Zoning Plan For
Subdivision
Beechwood Creek
Land Lot 151 18th District
Cobb County, Georgia

Sheet No.
Z-1

PETITION NO: Z-86

ZONING COMMENTS:

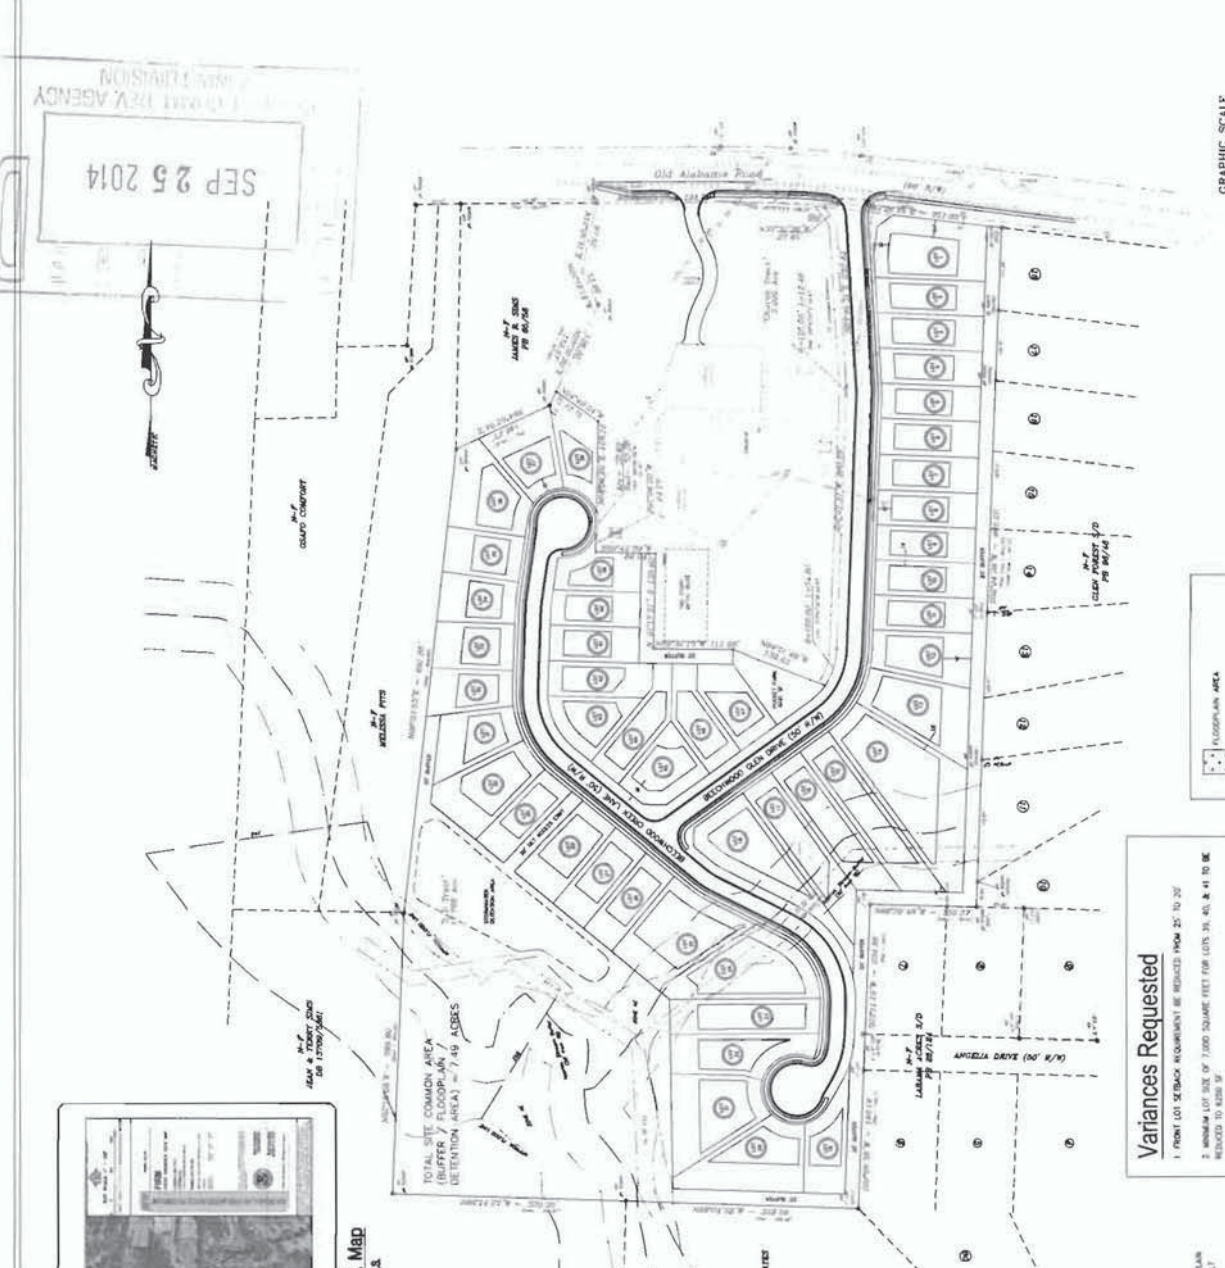
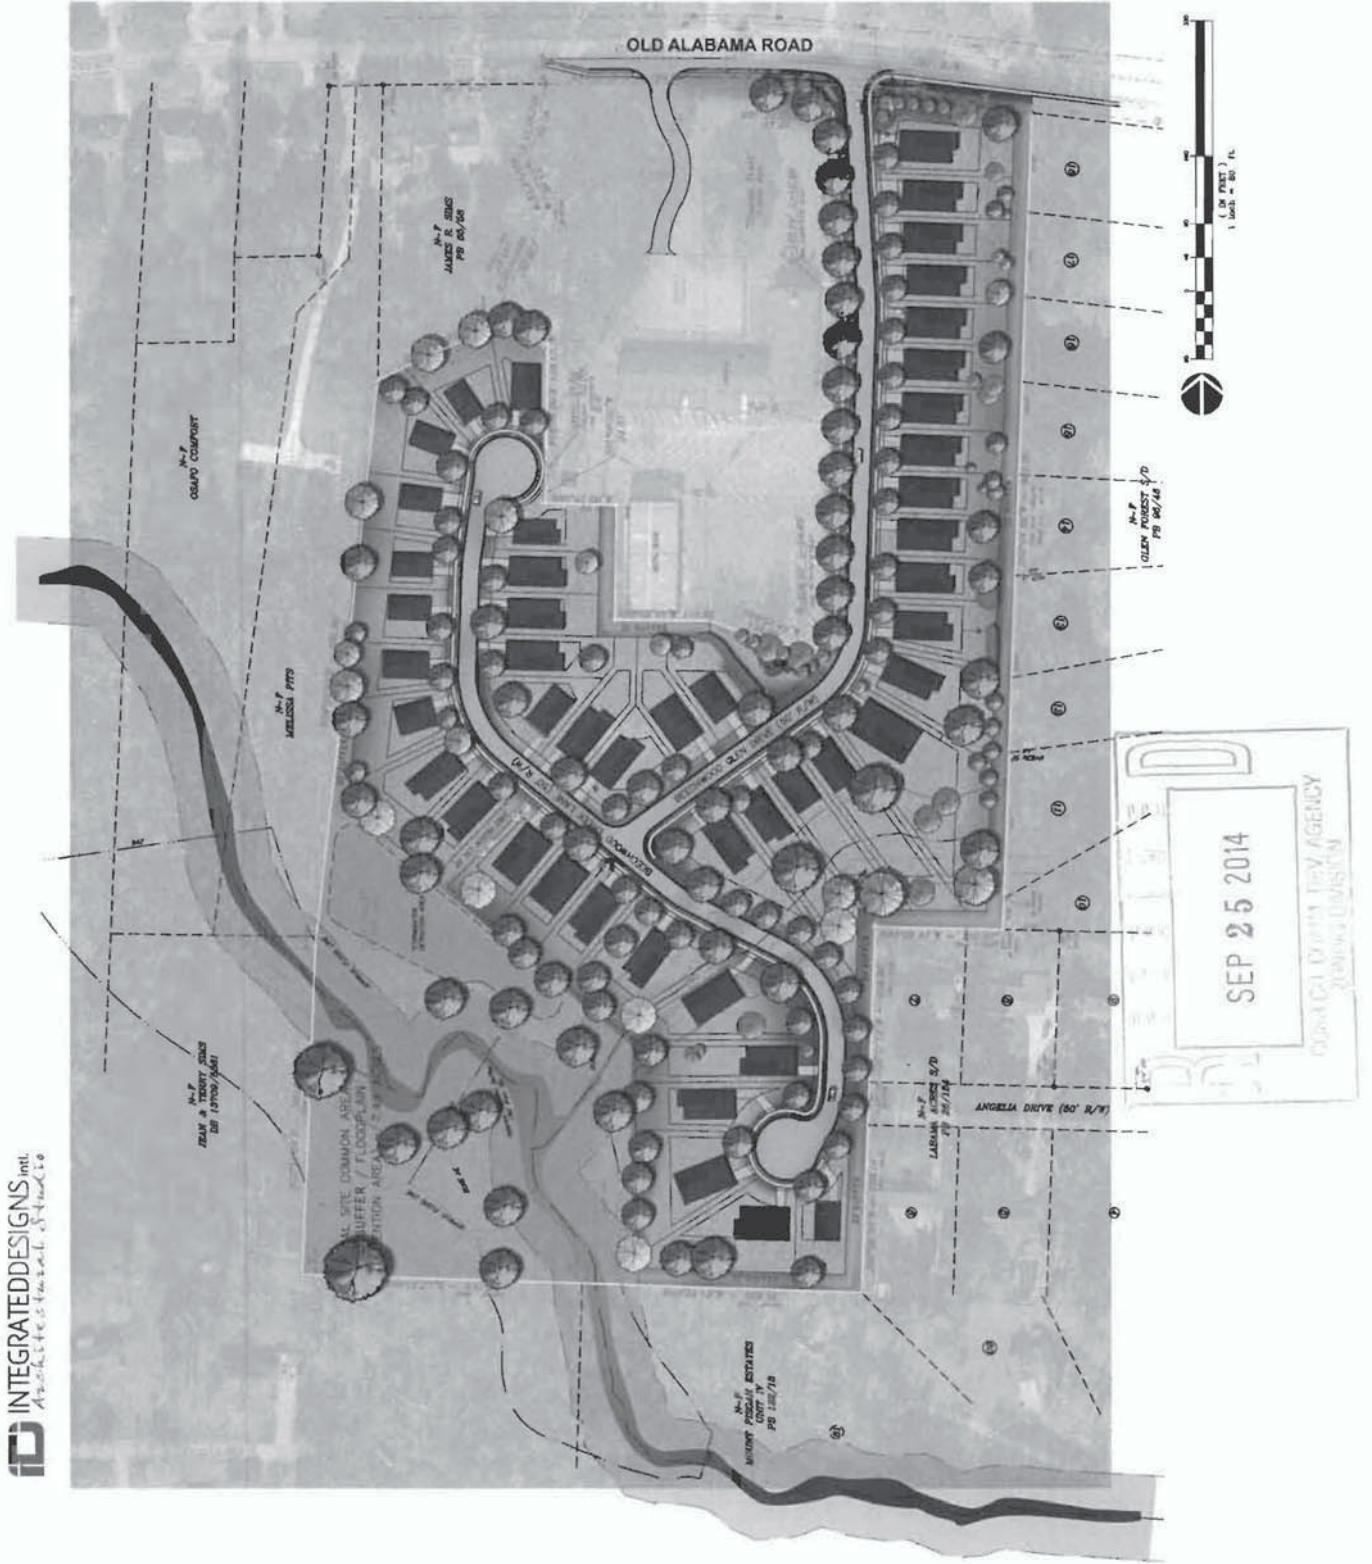
- Provide comprehensive hydrology/stormwater controls to include development of out parcels.
- Submit all proposed site improvements to Plan Review.
- Any **spring activity** uncovered must be addressed by a qualified geotechnical engineer (PE).
- Structural fill _____ must be placed under the direction of a qualified registered Georgia geotechnical engineer (PE).
- Existing facility.
- Project must comply with the Water Quality requirements of the CWA-NPDES-NPS Permit and County Water Quality Ordinance.
- Water Quality/Quantity contributions of the existing lake/pond on site must be continued as baseline conditions into proposed project.
- Calculate and provide % impervious of project site.
- Revisit design; reduce pavement area to reduce runoff and pollution.

- No Stormwater controls shown _____
- Copy of survey is not current – Additional comments may be forthcoming when current site conditions are exposed.
- No site improvements showing on exhibit.

1. This entire site discharges to the southwest into Pine Branch that traverses the southwest corner of the property. There is a small tributary to Pine Branch that crosses the southeast corner of the parcel. Both of these streams have 50-foot stream buffers and an additional 25-foot impervious setback.
2. The available building footprints for Lots 15-17 appear to be severely limited by the impervious setback buffer. Lots 24 & 25 do not appear buildable. A revised lot layout is needed to address these issues.
3. A 20-foot drainage easement will likely be required along the rear of lots 31-36 to limit offsite bypass of runoff. This will need to be taken into consideration if any perimeter landscape buffers are proposed.

- B. It is Staff's opinion that the applicant's rezoning proposal may have an adverse affect on the usability of adjacent or nearby property. A previous request for 34 lots in the Conservation Subdivision zoning category was deleted to R-15 for 27 lots.

- E. It is Staff's opinion that there are existing and changing conditions affecting the use and development of the property which give supporting grounds for deleting the applicant's rezoning proposal. A previous request to rezone to CS for 34 lots was eventually deleted to R-15 for 27 lots as part of (Z-187 of 2005 – minutes attached). The proposed density is over the maximum of 2.5 units per acre allowed in the LDR land use category, and is also higher than several other subdivisions in the area.

Based on the above analysis, Staff recommends DELETING to R-15 subject to the following conditions:

- Site plan to be approved by the Board of Commissioners, with the District Commissioner approving minor modifications;
- Maximum of 32 lots;
- Fire Department comments and recommendations;
- Water and Sewer Division comments and recommendations;
- Stormwater Management Division comments and recommendations; and
- Department of Transportation comments and recommendations.

OLD ALABAMA RD CHURCH PROPERTY

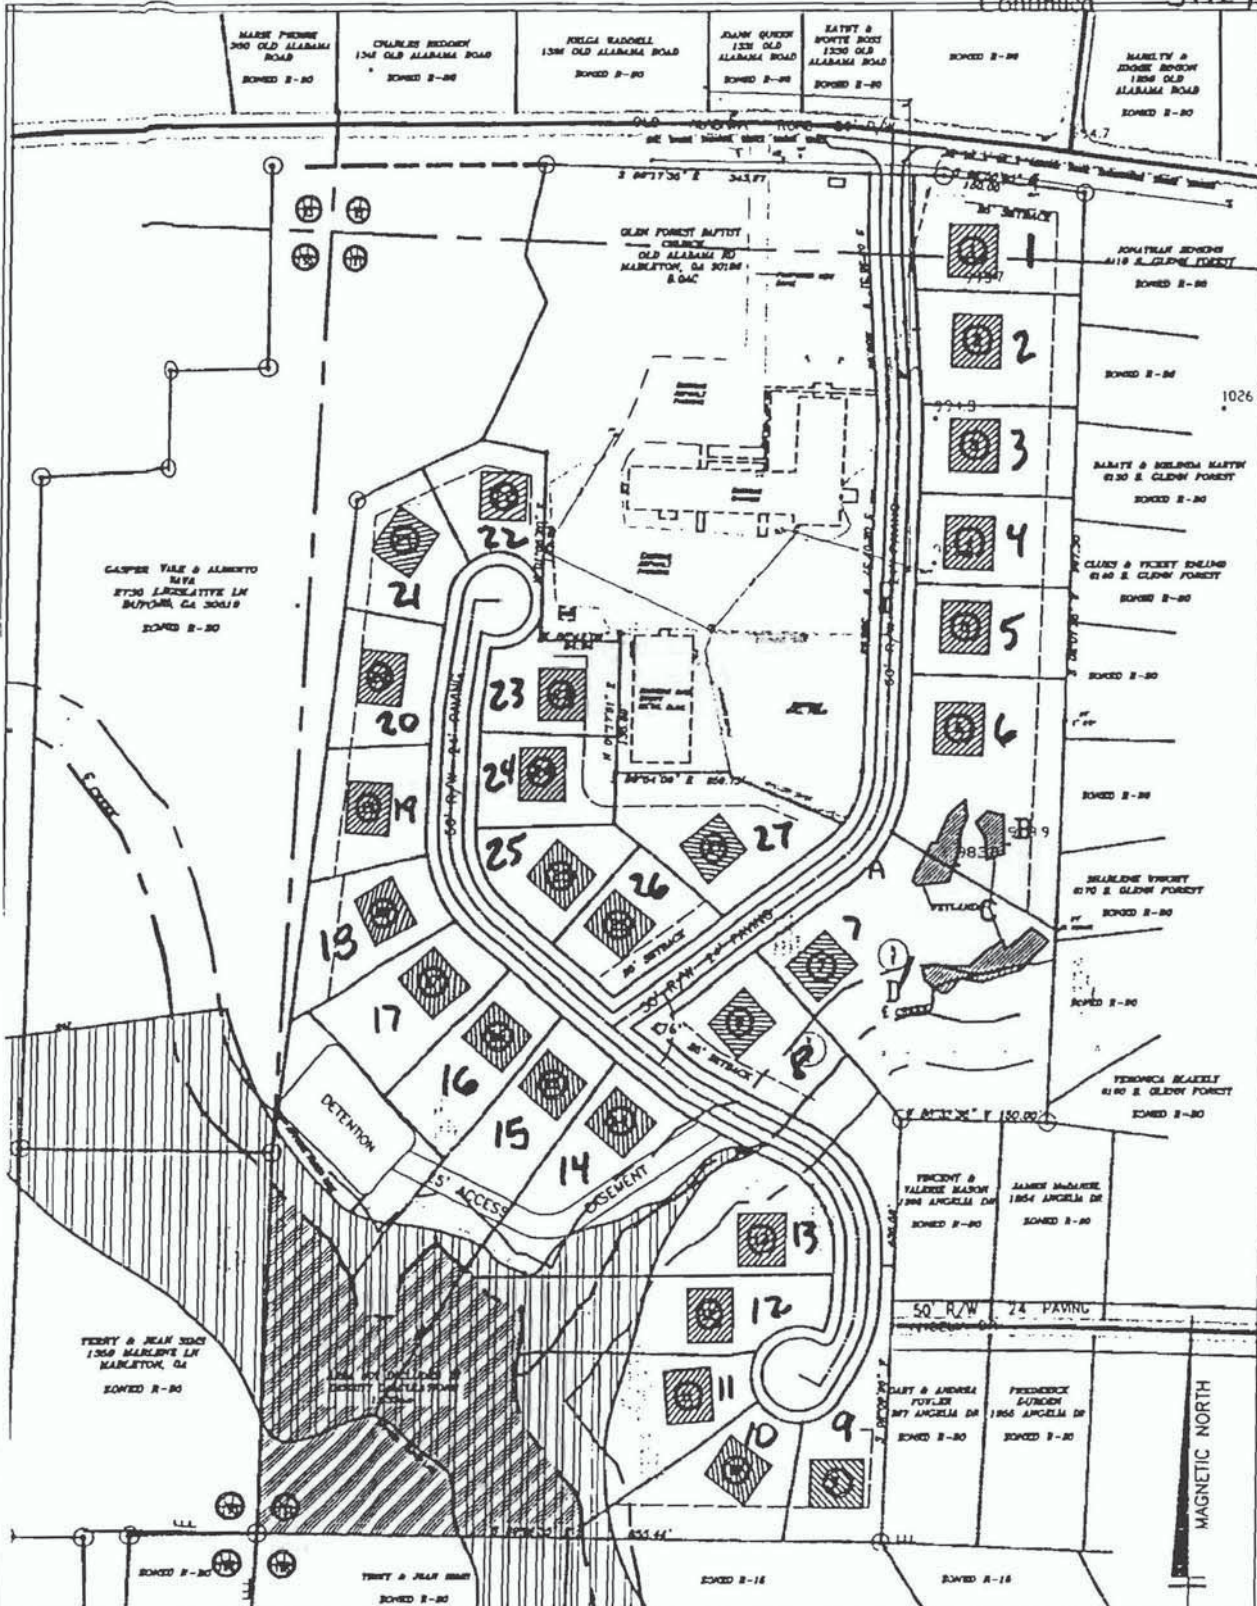
- 8) Revised Plan presented at Staff Zoning Analysis Review of 11-18-05 showing increased density from 6 lots to 8 in northeast and eliminating southwest cul-de-sac with ensuring rearrangement of lots and detention. Lot count has increased from 34 to 37. Detention / Water Quality-Best Management Practice is now without access from public road and has been moved into the Open Space area.

- 8.1) All previously made Drainage Comments remain in force.
 - 8.2) The relocation of the detention / Water Quality-Best Management Practice into an isolated area without public road access renders it unacceptable for Public / County perpetual maintenance. Recommend an operating manual be provided for County Review at Plan Review along with a funding arrangement.

- 8.3) This new plan shows the Open Space area increasing, but, at same time the detention / Water Quality-Best Management Practice located therein encumbering some of the Open Space. Suggest the Open Space calculations be refined to be compatible with plan.

- 8.4) The very small lots running against stream buffers and floodplain offer very little latitude for change in detail design. This must be considered a true conceptual plan subject to change. Therefore, Stormwater Management must reserve full right of review and comment for detail plans at Plan Review.
